[3] Redline Revision No. 3
April 5, 2012
MOT Phase Change

[3] **ULTIMATE TRAFFIC SIGNAL PLAN**

US 50 (OCEAN GATEWAY) AT OCEAN LANDING EAST ENTRANCE
BERLIN, MARYLAND

TRAFFIC SIGNAL PLAN

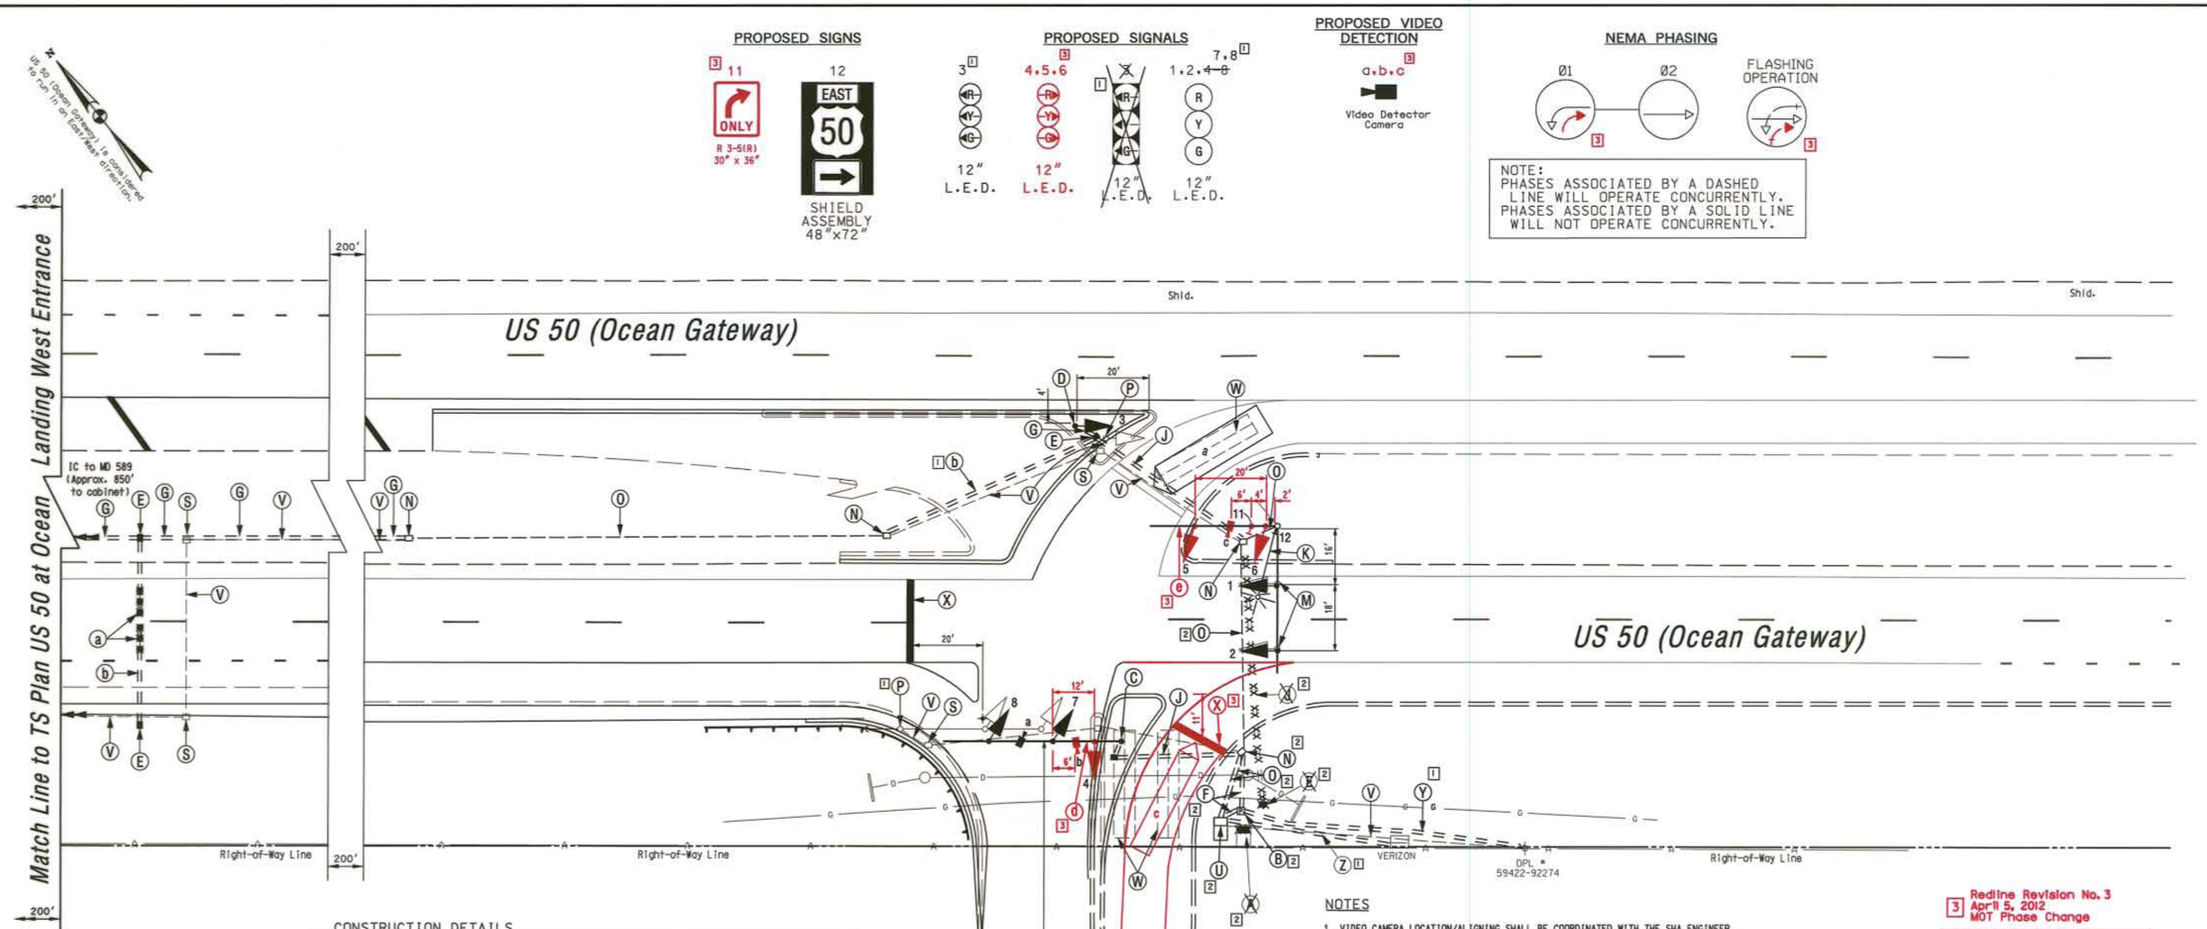
[2] ~~A. Install base mounted NEMA 3 cabinet and necessary equipment (Note: two 2 in. and two 4 in. PVC conduit bend). Relocate existing controller.~~ [1]

[3] ~~L. On existing mast arm install signal heads, signs and video detector cameras.~~

P. Remove existing steel pole and all attached equipment. Temporary Back Guy as necessary during construction. [1]

U. Remove existing base mounted cabinet ~~relocate existing controller to new cabinet~~. [1]

V. Cap and abandon existing conduit. Install new Cabinet/Controller on existing Foundation. [2] Update electrical service to current standards.

[3] d. Install signal head and video detector camera as shown.

[3] e. Use existing mast arm install signal heads, signs and video detector camera.
